ADDENDUM NO. 001

PROJECT NAME: Morrison Center Addition Project
UNL PROJECT NUMBER: **A126P003**
UNL BID INVITATION NUMBER: **909061-11**

CONSULTANT: Farris Engineering
ADDRESS: **11239 Chicago Circle**

ADDENDUM DATE OF ISSUANCE: November 22, 2011
DATE OF BID OPENING: **December 7, 2011**

VAV - NON-LAB TERMINAL UNIT SCHEDULE

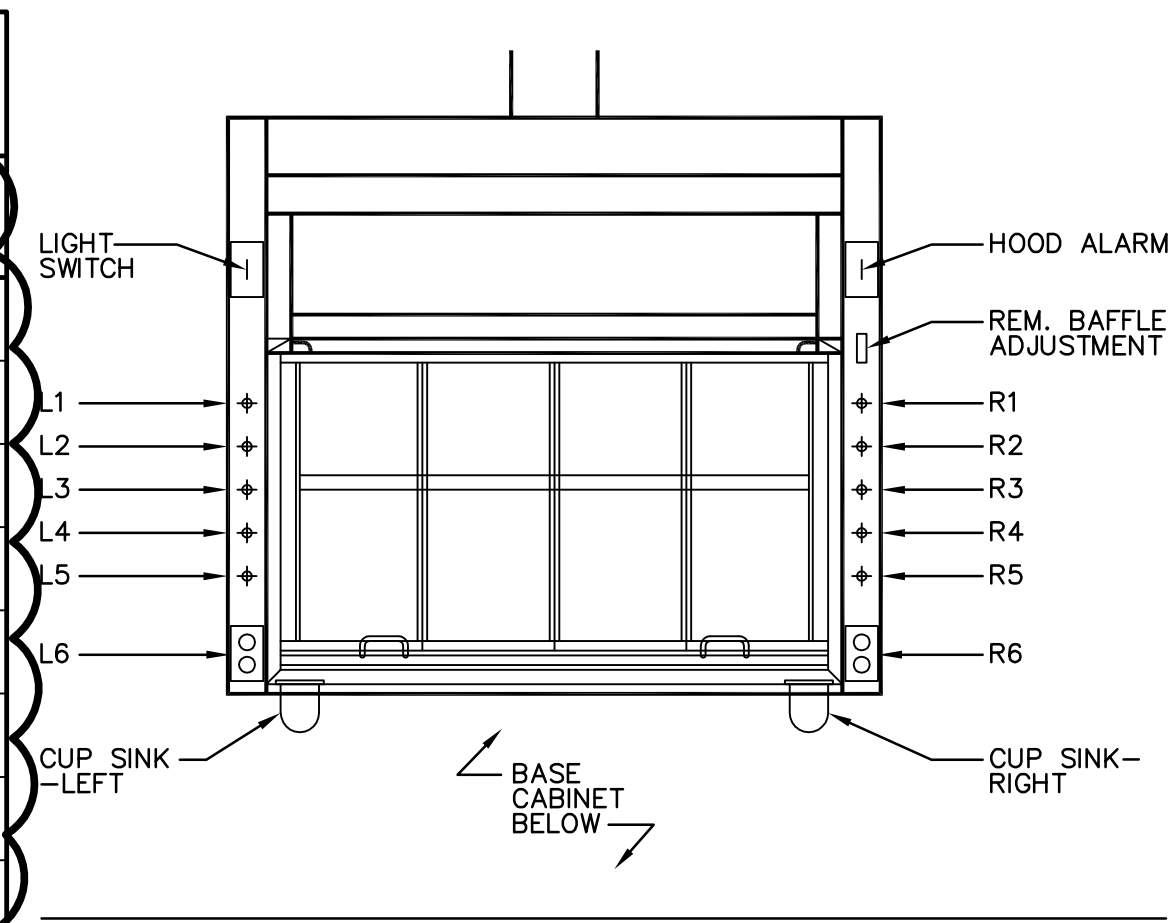
20. SHEET NVM-0101, MECHANICAL SCHEDULES: SCHEDULE: "VAV - Non-Lab Terminal Unit Schedule", VAV-XXX-16 gets Remark 7 added to it. Remark 7 reads " SUPPLY SILENCER SHALL BE VIBRO-ACOUSTICS RECTANGULAR FILM-LINED, MEDIUM VELOCITY, LOWEST F-NUMBER AVAILABLE. SUPPLY SILENCER - 24" X 18" CONN./OVERALL SIZE, 3' LONG". See updated drawing. See Plate 7 of 9.

Project No: 102002	Addenda No: 1	Dwg Ref No: NVM-0103
Date: 11-21-2011	Checked By: PAM	Addenda Sht: 9 of 9
		Drawn By: MDB

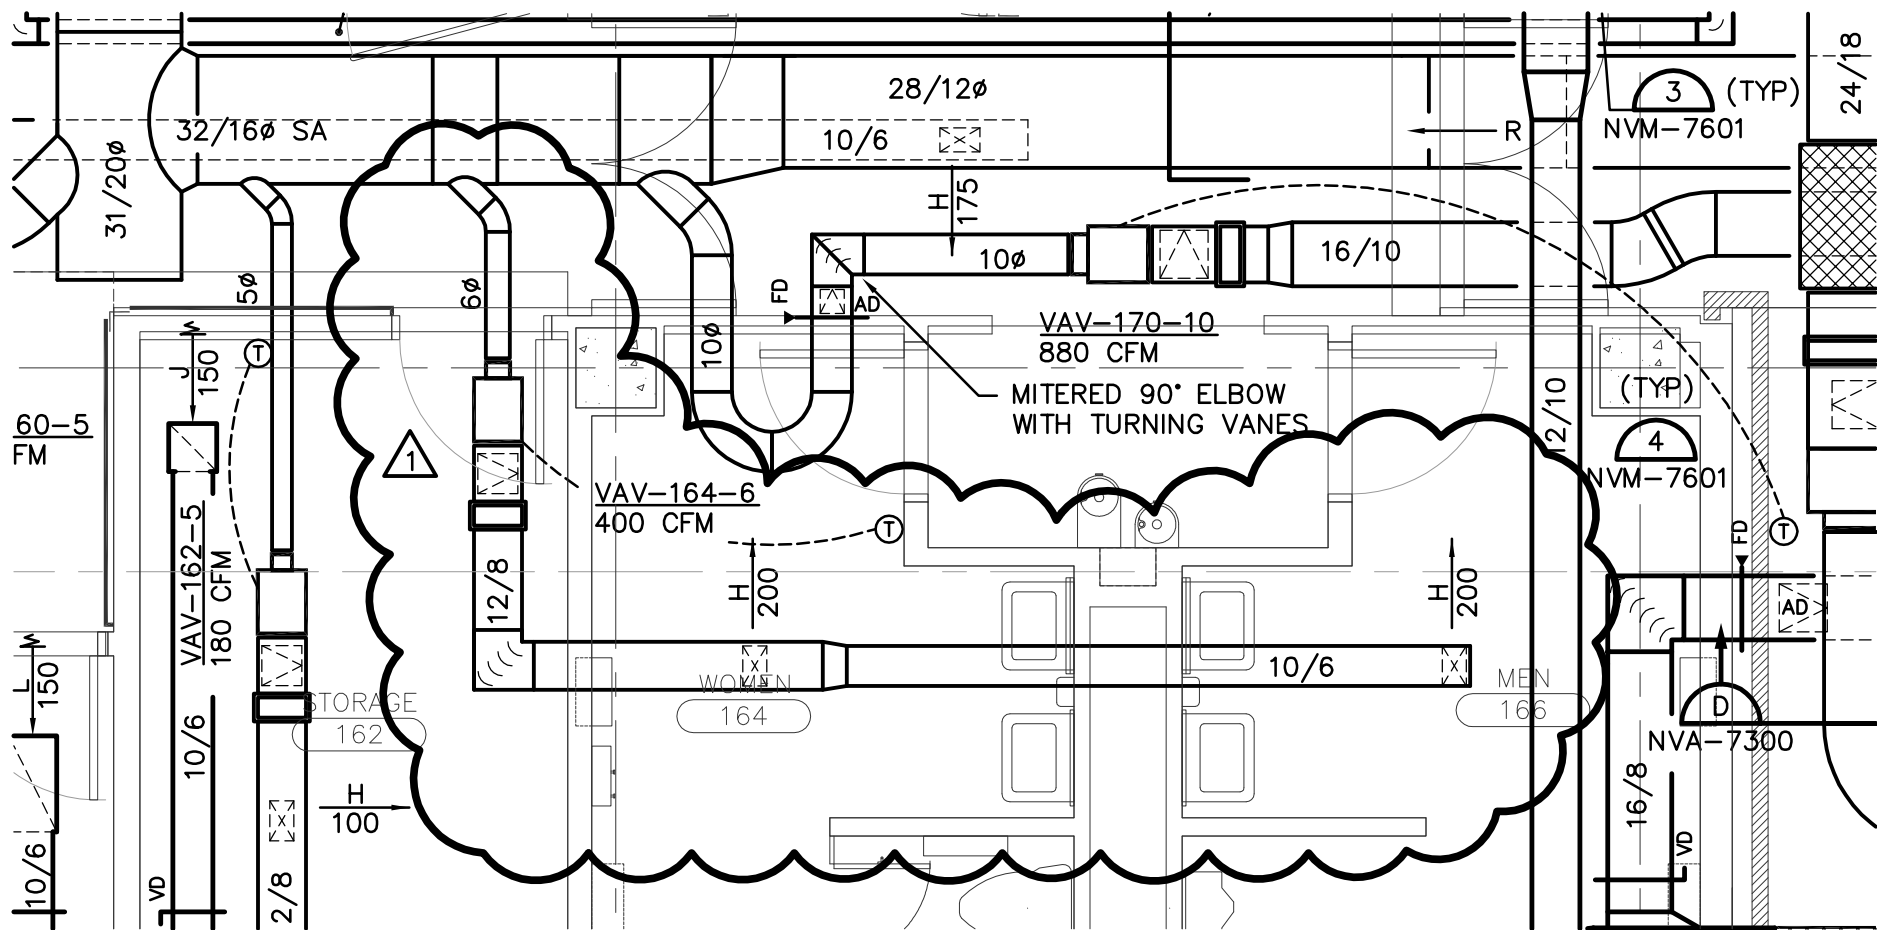
22. SHEET NVM-0103, MECHANICAL SCHEDULES: SCHEDULE: " VAV Terminal Unit and Room Balance Schedule", Women 164 and Men 166 get consolidated to a single supply box, VAV-164-6. See attached Plate 9 of 9.

Dwg Ref No: **NVMH1-E-**

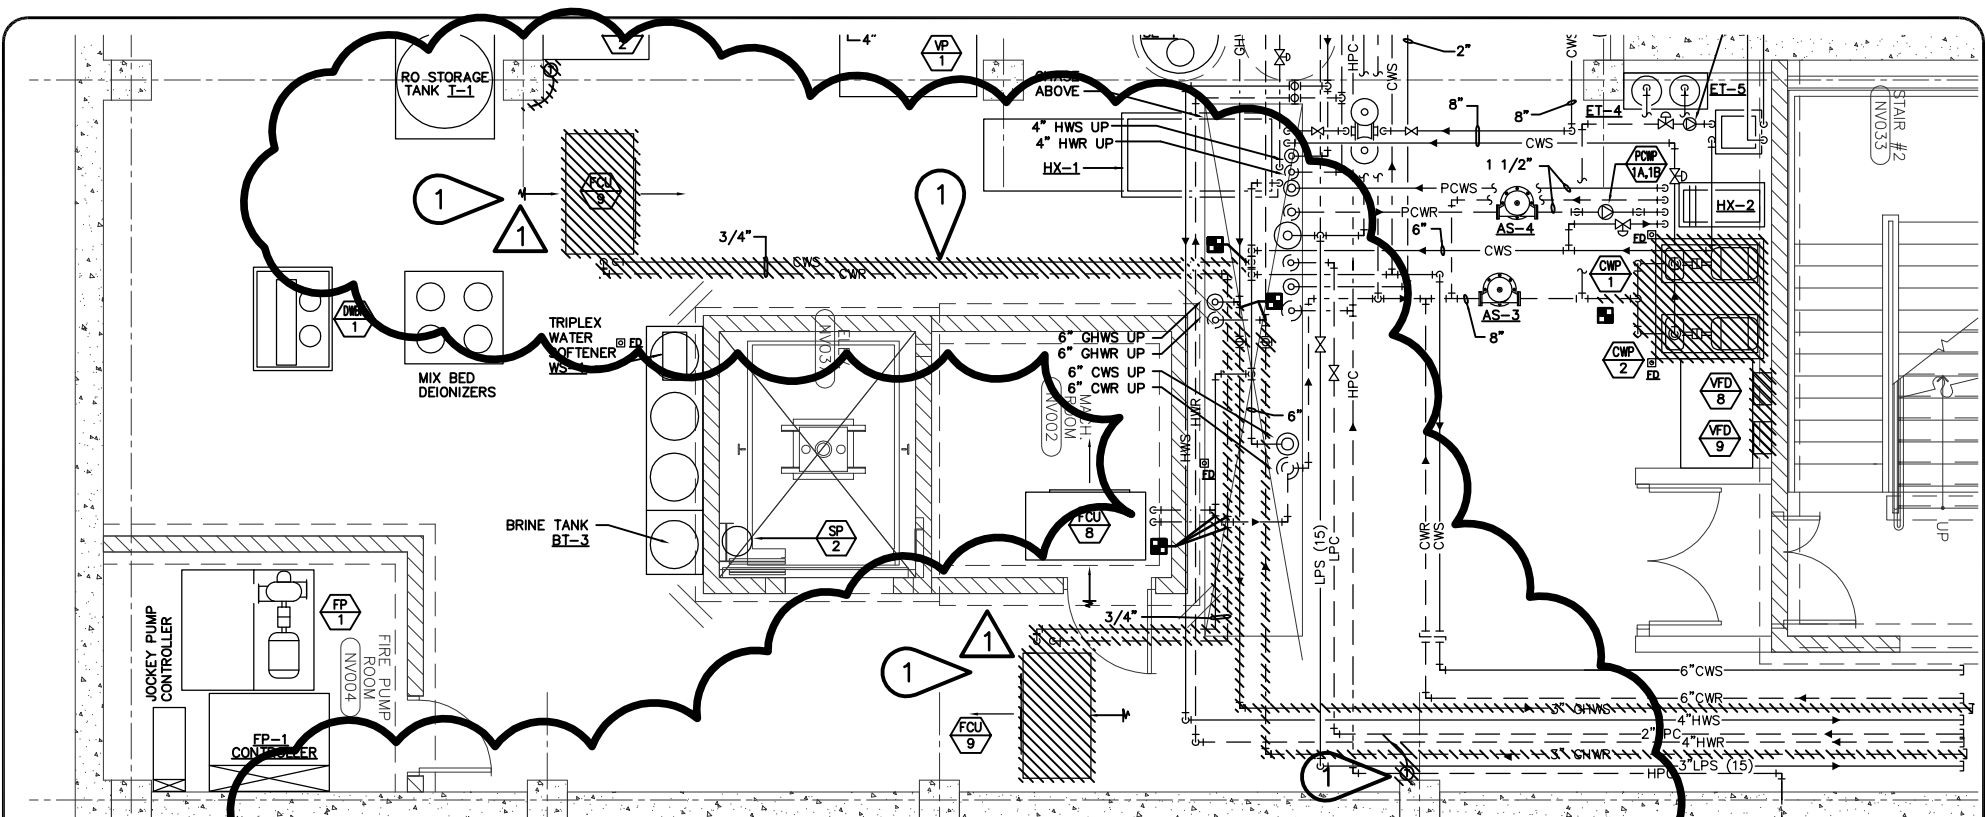
4. SHEET NVMH1-E-, MECHANICAL - HVAC SECTOR E FIRST LEVEL FLOOR PLAN: Rooms Women 164 and Men 166 will no longer be served by two 5" Supply VAV boxes individually, and will now be served both by a single 6" Supply VAV box, VAV-164-6 (400 CFM). See attached Plate 1 of 9.

NVMP0DM

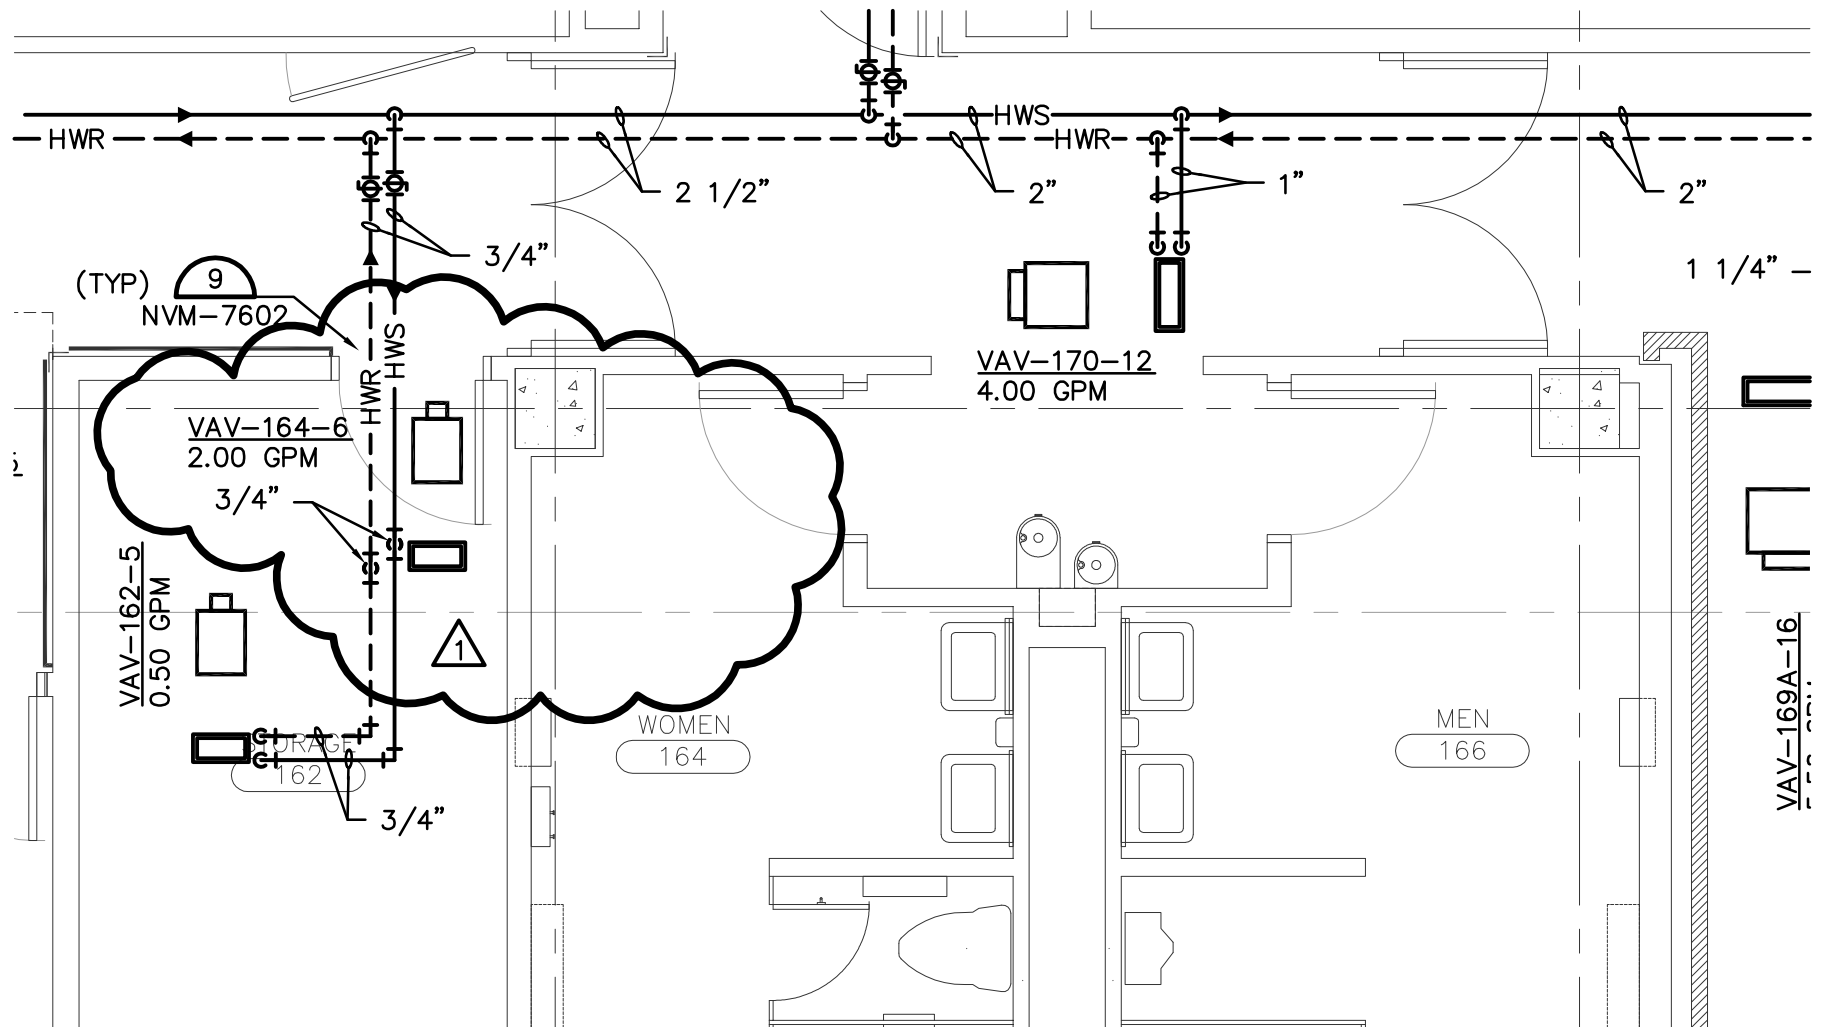
9. SHEET NVMP0DM, MECHANICAL – PIPING BASEMENT LEVEL FLOOR PLAN-DEMOLITION: Add the follow sentence to keynote 1: "Contractor to turn FCU removed over to UNL-BSM", per Plate 3 of 9.

Project: Ken Morrison Life Sciences Research Center Addition		
	Sheet Title: MECHANICAL PIPING - SECTOR E FIRST LEVEL FLOOR PLAN		
	Project No: 102002	Addenda No: 1	Dwg Ref No: NVMP1-E-
	Date: 11-21-2011	Checked By: PAM	Addenda Sht: 2 of 9 Drawn By: MDB

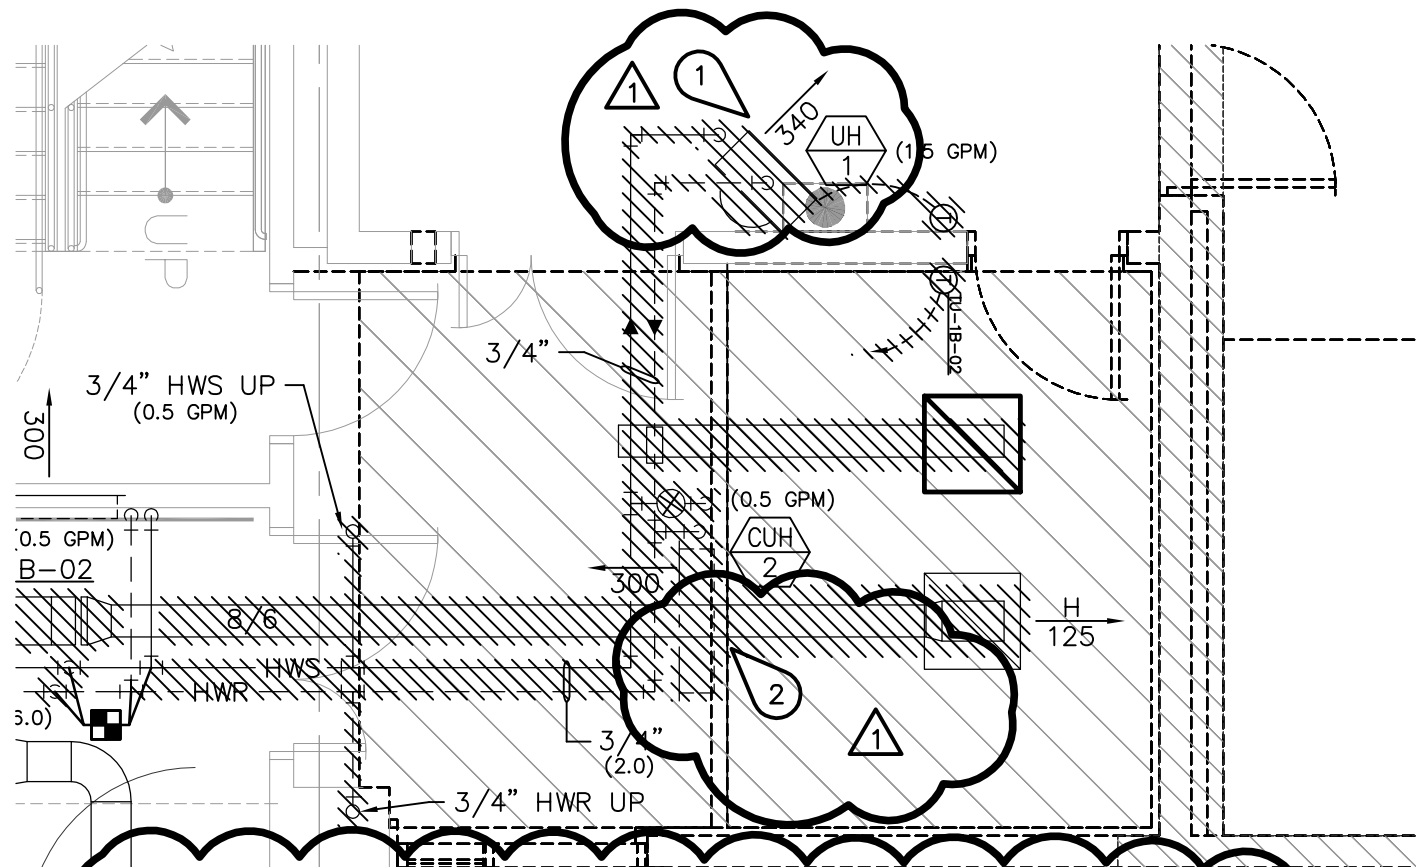
7. SHEET NVMP0-E-, MECHANICAL - PIPING SECTOR E BASEMENT LEVEL FLOOR PLAN: Keynote 3 should read "2" ", rather than "1-1/2" ".
8. SHEET NVMP1-E-, MECHANICAL - PIPING SECTOR E FIRST LEVEL FLOOR PLAN: VAV boxes VAV-164-5 and VAV-166-5 get deleted, and replaced with VAV-164-6, at 2.00 GPM, 3/4" piping. All other branch sizes will remain the same.

- D. Change keynote label at existing CUH-1 to read 2 in lieu of 3 shown.
11. SHEET NVMP1-E-, MECHANICAL – PIPING SECTOR E FIRST LEVEL FLOOR PLAN: VAV boxes VAV-164-5 and VAV-166-5 get deleted and replaced with VAV-164-6, at 2.00 GPM, 3/4" piping. All other branch sizes will remain the same.

Addenda Sht: **4 of 9**

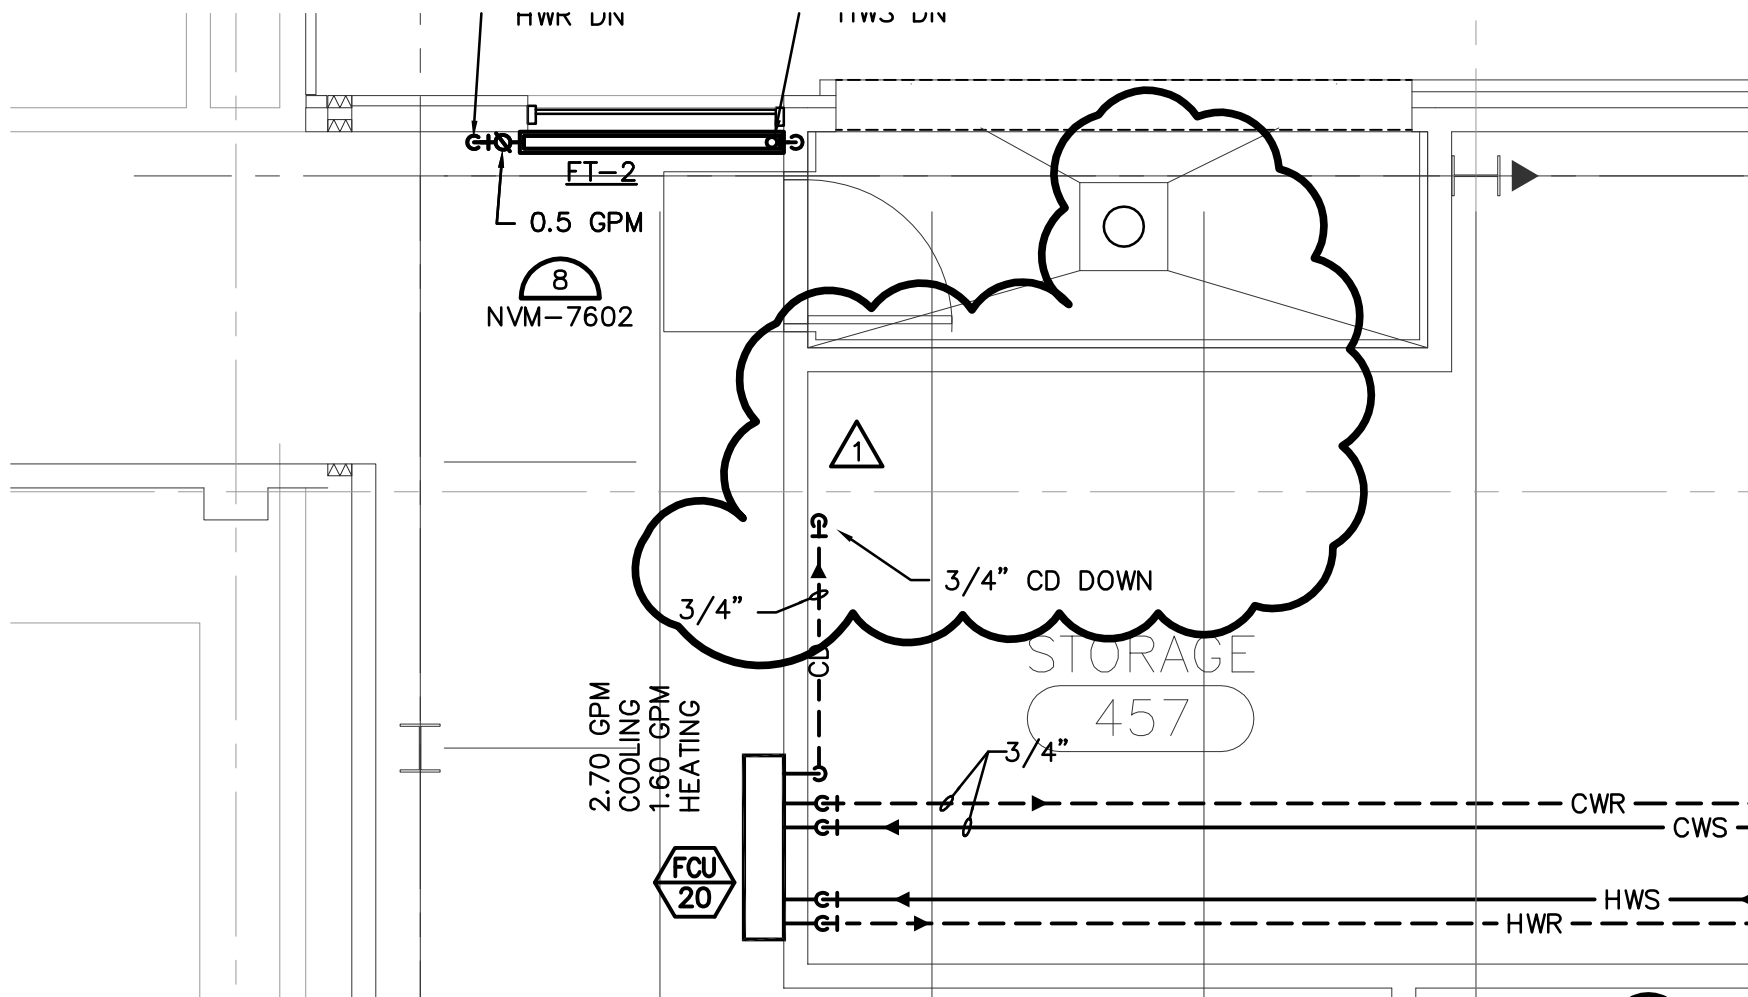
10. SHEET NVMP1DM, MECHANICAL – PIPING SECTOR E FIRST LEVEL FLOOR PLAN-DEMOLITION (Per Plate 4 of 9):
 - A. Add the follow sentence to keynote 1: "Contractor to turn unit heater removed over to UNL-BSM."

- B. Add the follow sentence to keynote 2: "Contractor to turn cabinet unit heater removed over to UNL-BSM."
 - C. Add keynote 1 label to existing unit heater UH-1.
